Addendum 4

Project No	5437	Date	January 28, 2016
Project	Centre for Aquaculture and Environmental Research ROOF REPLACEMENT 4160 Marine Drive West Vancouver, BC Department of Fisheries and Oceans - West Vancouver Laboratory

FISHERIES AND OCEANS CANADA WEST VANCOUVER LABORATORY, BC ROOF REPLACEMENT MAIN LABORATORY, PUMP HOUSE

1 ROOF PLAN
SCALE: 1/8"=1'-0"

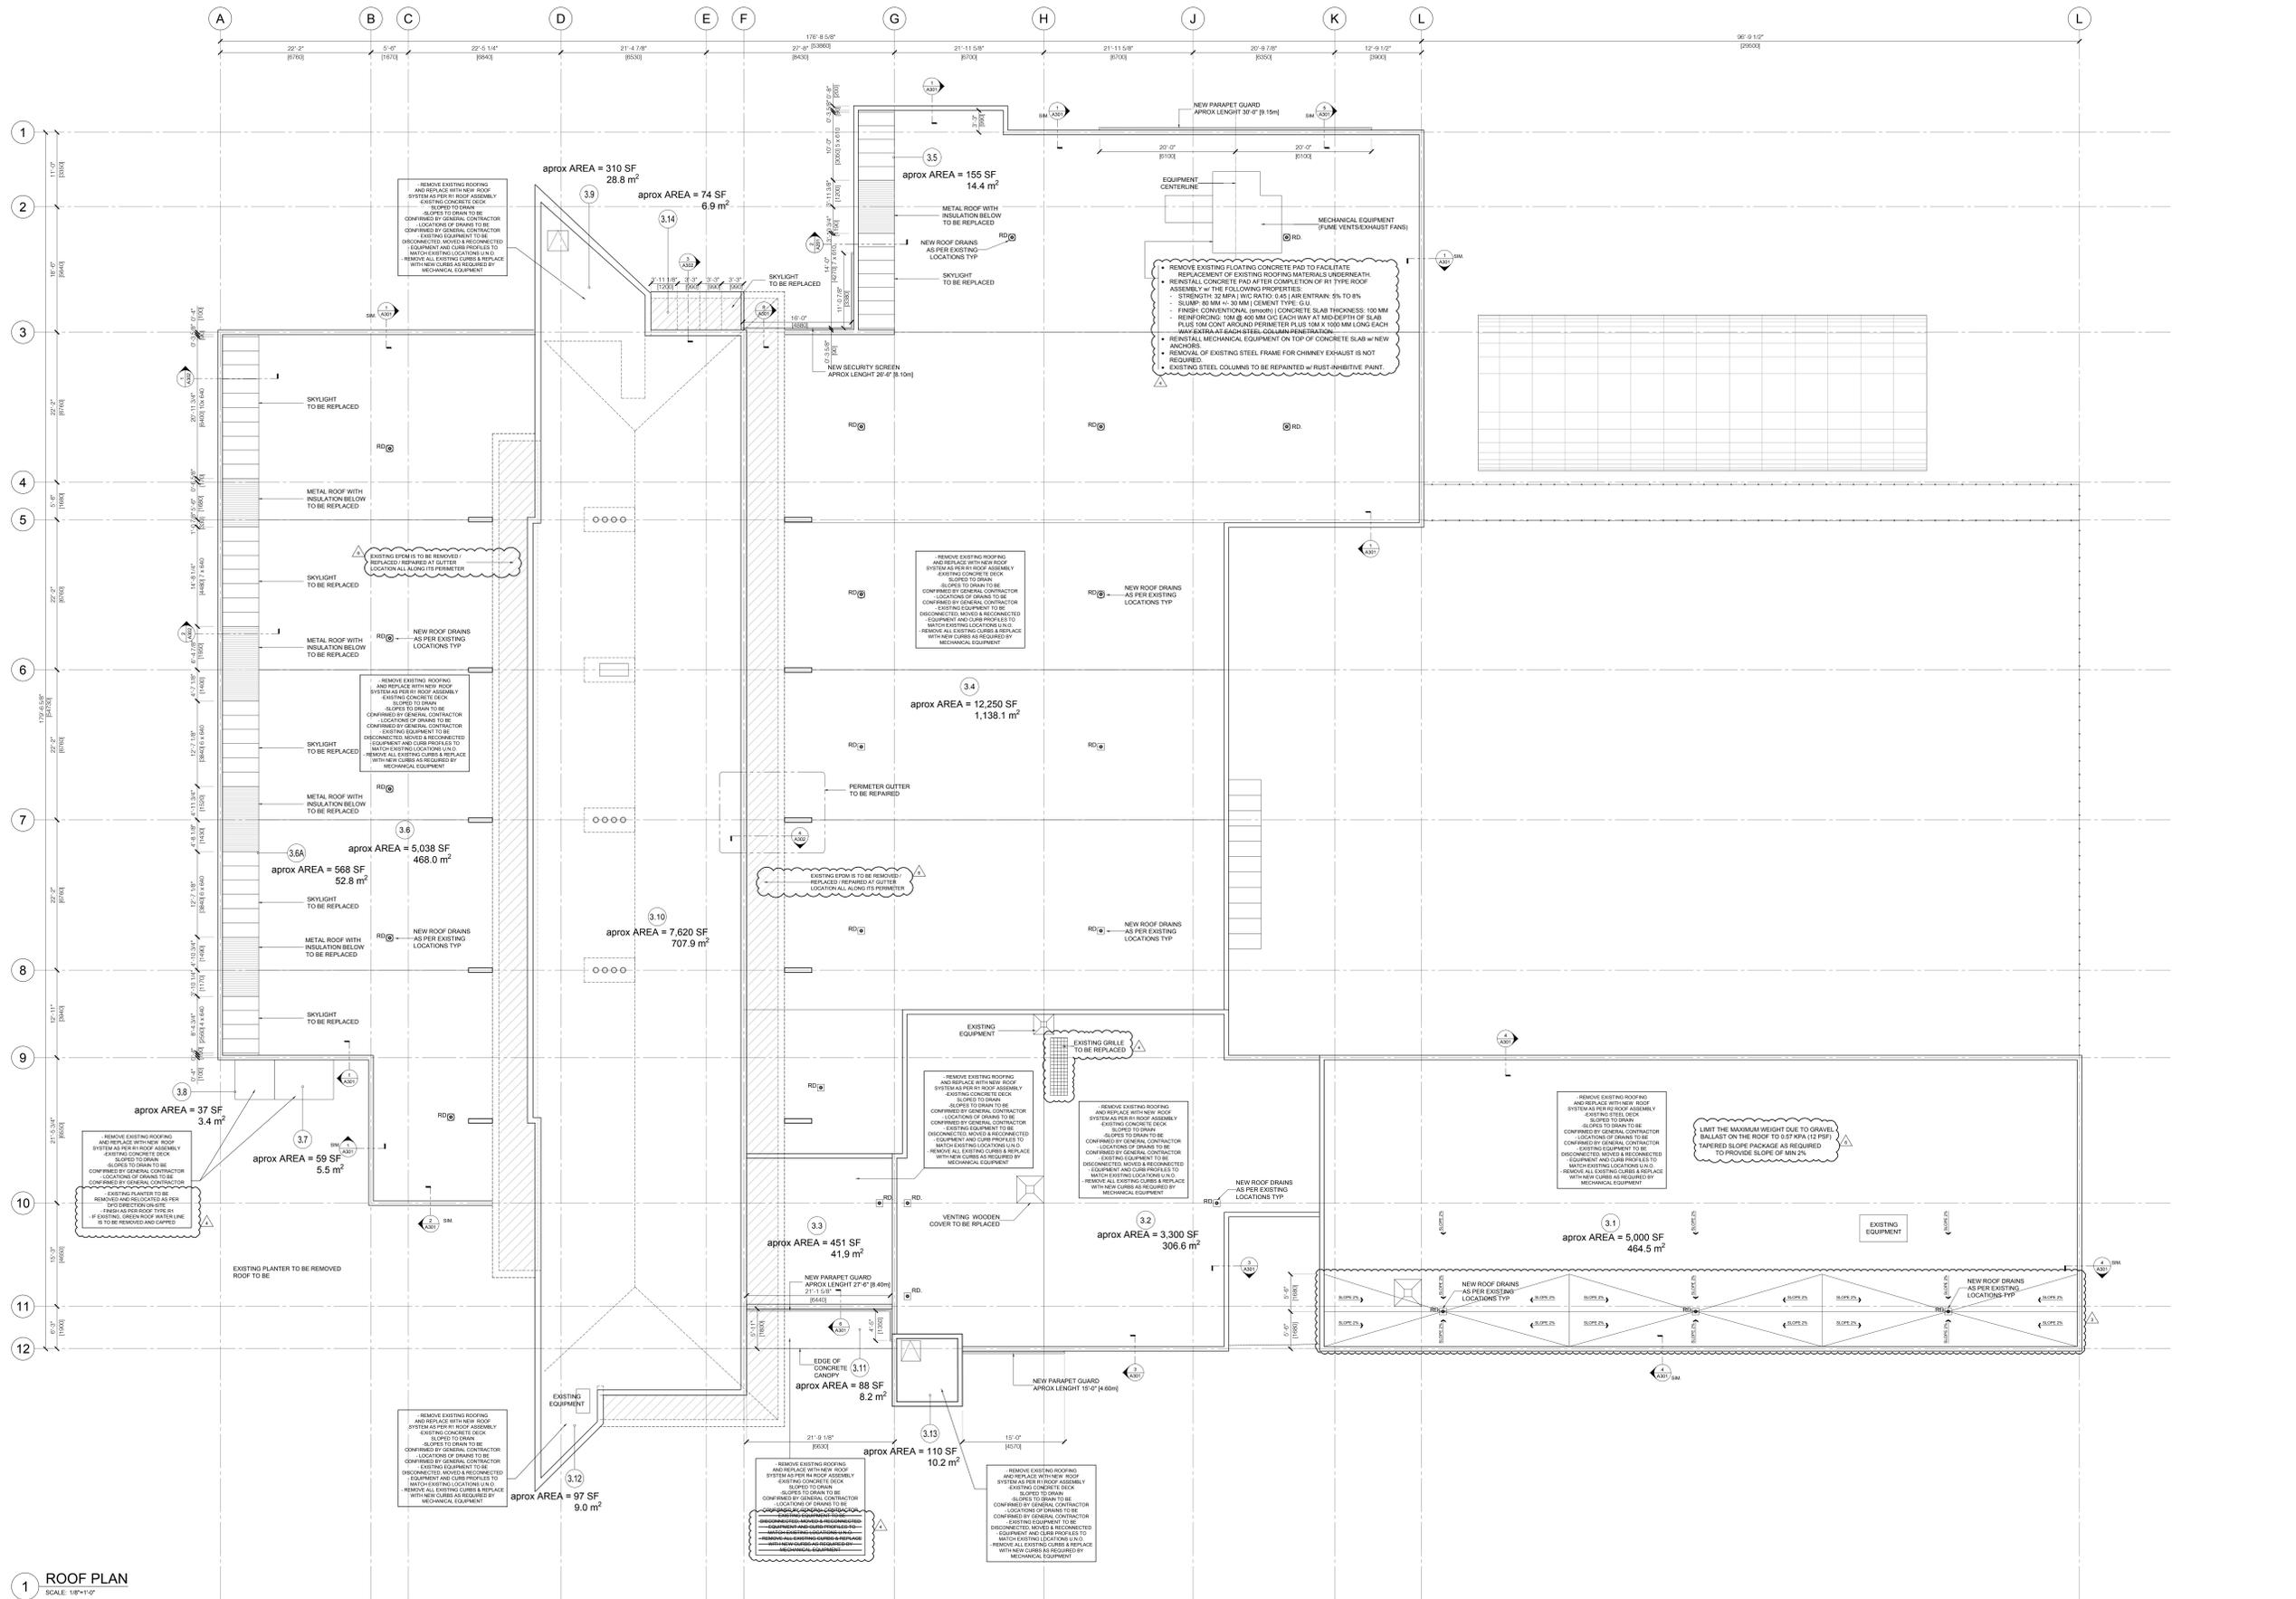
Revise: - Roof 3.1:

- Roof Type R2
- Limit maximum weight due to gravel ballast to 0.57 kPa (12 PSF).
- 1 layer loose laid 2" XPS Insulation (R-10 c.i.).
Tapered slope package as required to provide slope of min. 2%

Add: - Roof 3.10:

- Existing EPDM membrane is to be removed/replaced/repared at gutter location all along its perimeter.

4 PARAPET DETAIL
SCALE: 3/4"=1'-0"

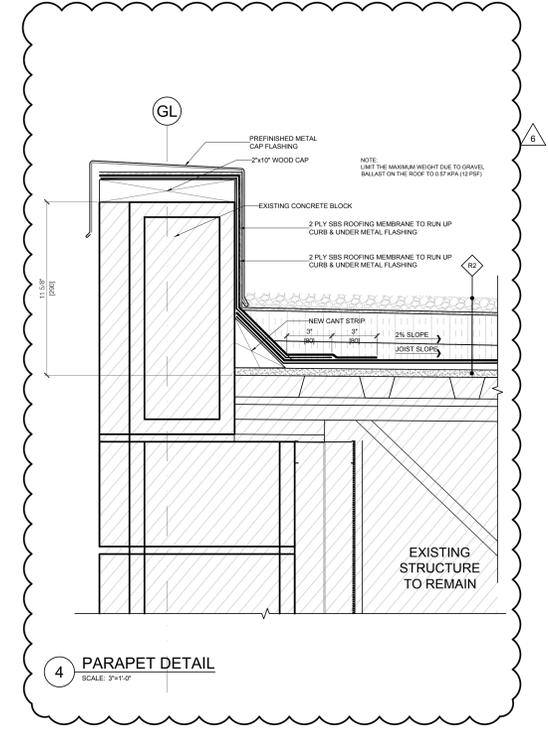
Revise: Detail 4

- Roof type R2
- Limit maximum weight due to gravel ballast to 0.57 kPa (12 PSF).
